Vieux Carré Commission Architecture Committee Meeting

Tuesday, March 24, 2026

RE: Plan Review Response – Structural
Project Address: 832 Esplanade Ave., New Orleans, LA

TYPICAL PIER AND FOOTING DETAIL

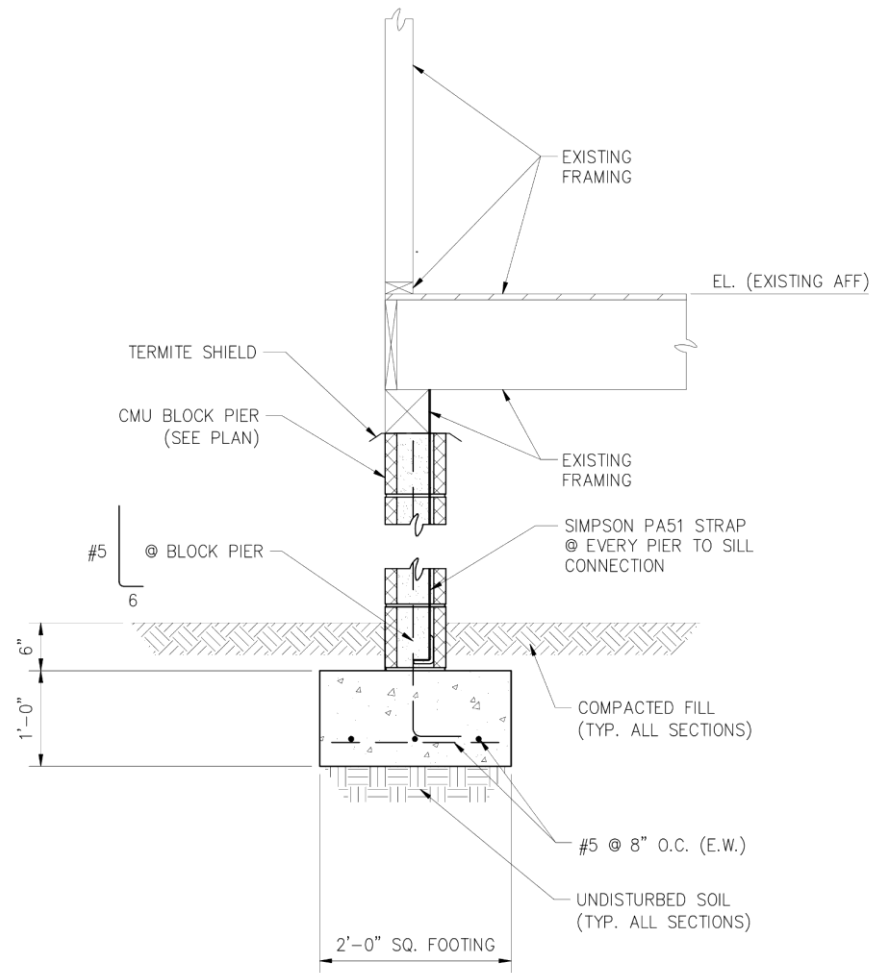
“Please provide more detail for the new pier added at the corner of the building labeled No. 5 located on LKHarmon Architects drawing A1.”

Axis Engineering has reviewed this condition and provided a detail for the new CMU pier and concrete footing, see attached detail labeled ‘TYP PIER & FOOTING DETAIL’.

PARTIAL 2nd FLOOR PLAN
SC: 1/4" = 1'-0"

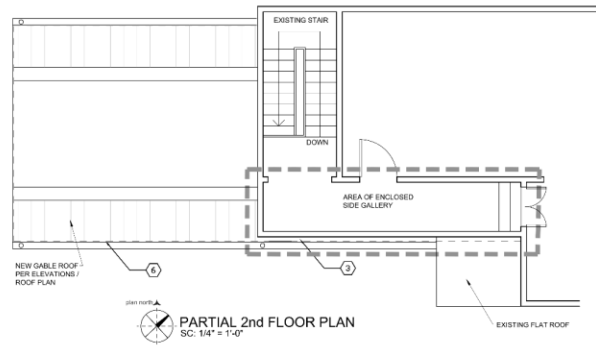
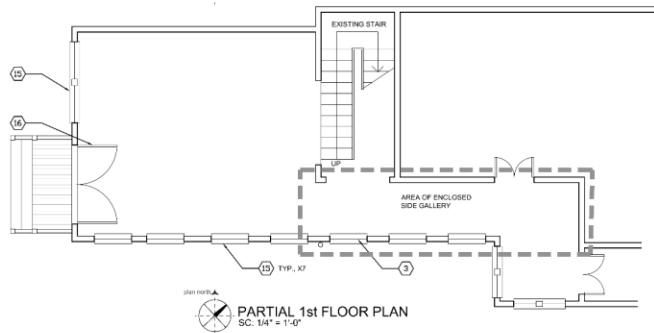
“Please provide verification that the existing foundation will support the added exterior wall for the closed-in side porch.”

Axis Engineering reviewed and evaluated the adequacy of the existing foundation system under the proposed renovation and additional loading and determined that the added exterior wall to the existing foundation system is acceptable.
